Product/Process Change Notice (PCN)

PCN Number: PCN_AbsSHC_20250512

Affected Series: WE-SHC

1. Tray

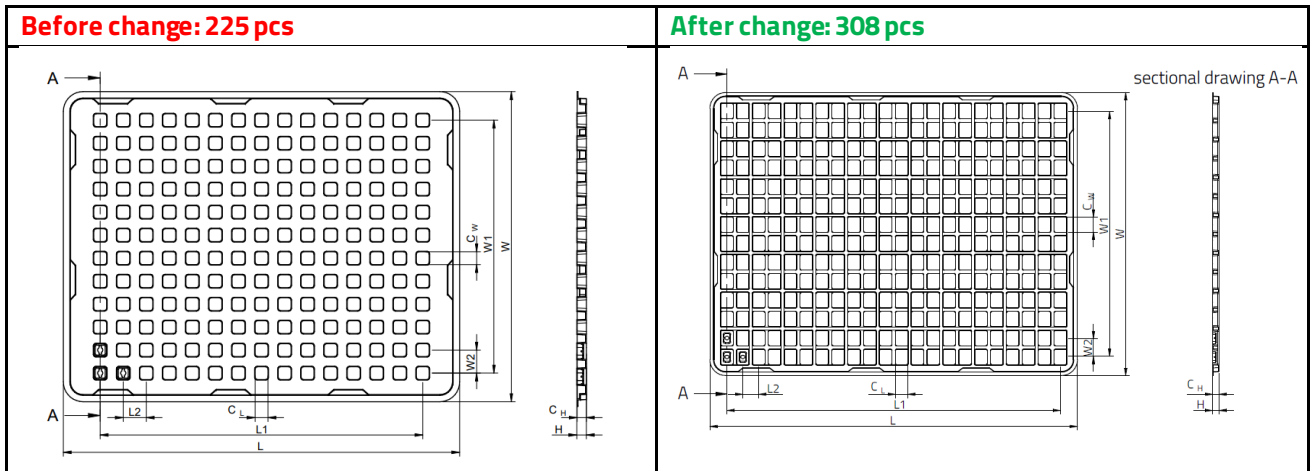
Due to the SPQ update from the table above, the packaging drawing will be updated accordingly with to the correct quantity.

Example : 3670087

2. Carton

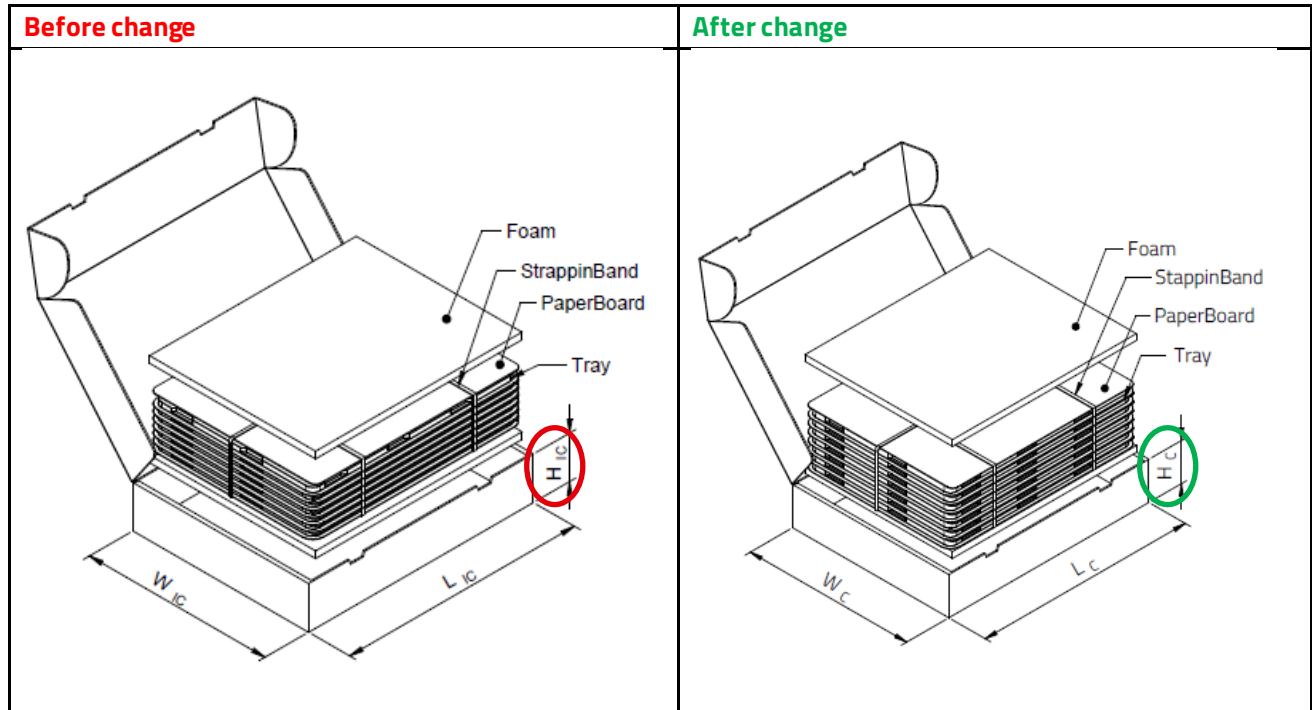
The dimension H_{1c} will be re-named as H_c for all affected part numbers.
